Addendum No. 1
Four Rivers Sanitation Authority
Plant Roadway Improvements
Capital Project No. 2406

This Addendum Number 1, dated July 20, 2026, for the above-referenced project, supersedes all contrary and conflicting information in the specifications and contract documents, which are hereby supplemented or revised as follows:

PLANT ROADWAY IMPROVEMENTS
CAPITAL PROJECT 2406

Sheet No.
3 of 33

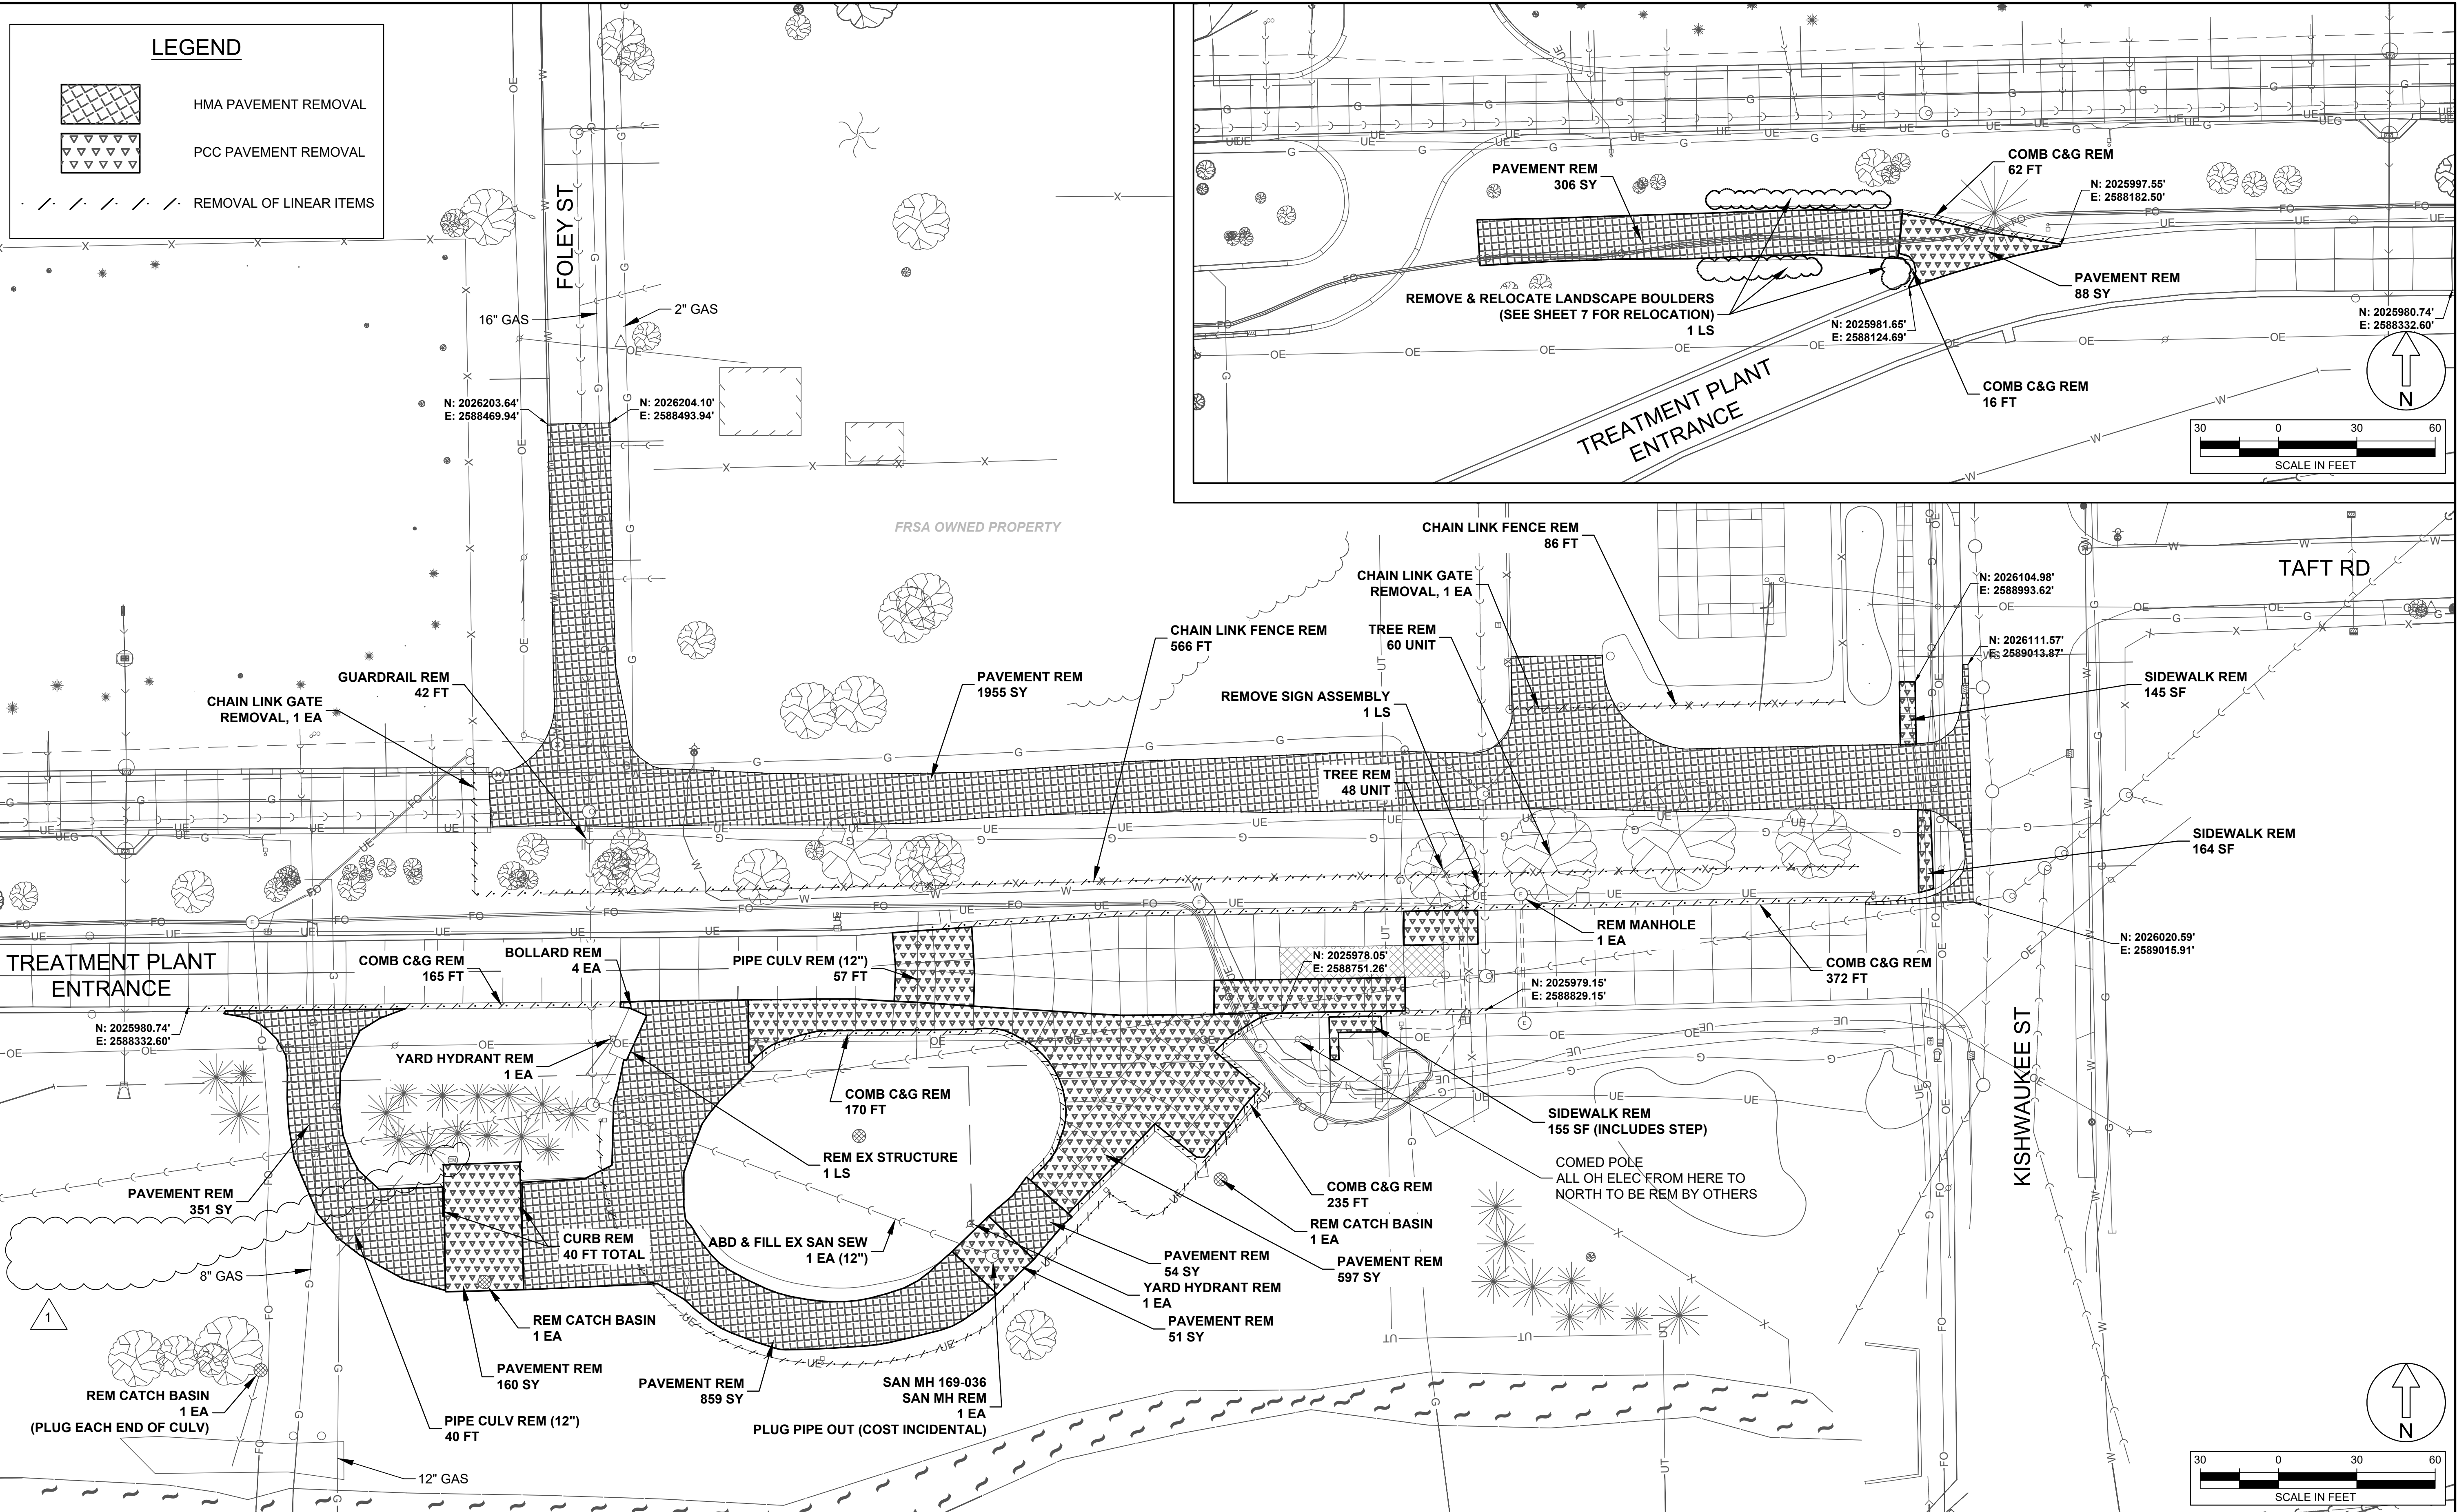
Sheet No. 3 – General Notes & Summary of Quantities

- REMOVE Sheet No. 3 of the construction plan set and REPLACE with Sheet No. 3 attached to this Addendum No. 1. The revised Sheet No. 3 removes the "Remove Electric Meter and Wooden Screen" pay item from the Summary of Quantities.
